5 November, 1993

Re: Southdown, Inc.
Siting Criteria Demonstration
Case No. 91-NF-0700
Permit to store Hazardous Waste Fuel

FIG. 13b ILLUSTRATES CONDUIT FLOW CONDITION

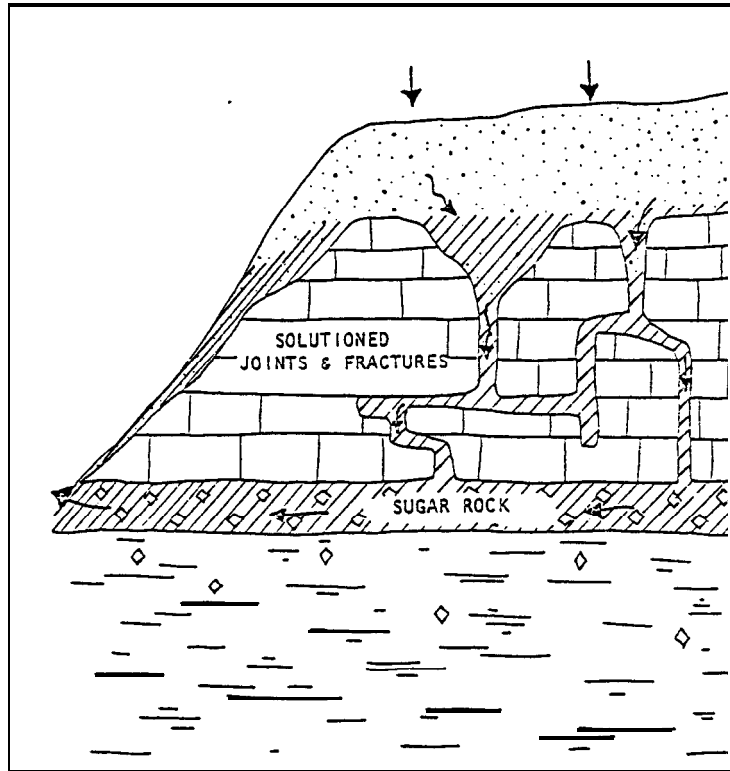
This report was sold to the public by the Wright State University Department of Geology as report number 770101. The Schmidt report includes a brief discussion of the 1874 Orton study of ground water flow in the area of the Quarry, and included the following figures that illustrate ground water flow in the area of the Southdown quarries.

If the Orton and Schmidt geologic reports are correct, uncontained toxic waste spills at this site will rapidly be absorbed by the sugar rock aquifer exposed on the quarry floor beneath the storage facility. After traveling 4 to 9 feet vertically through the porous dolomite sugar rock, the toxic wastes would flow horizontally through open conduits at the base of the aquifer, and issue in about 2500 feet “as the head spring of Ludlow Creek - one of the finest fountains of the county” (Orton, p.664). It is hard to see how, with such site geology, this site meets the Ohio Hazardous Waste Facilities Board criteria of “minimum risk of contamination of ground and surface water.”
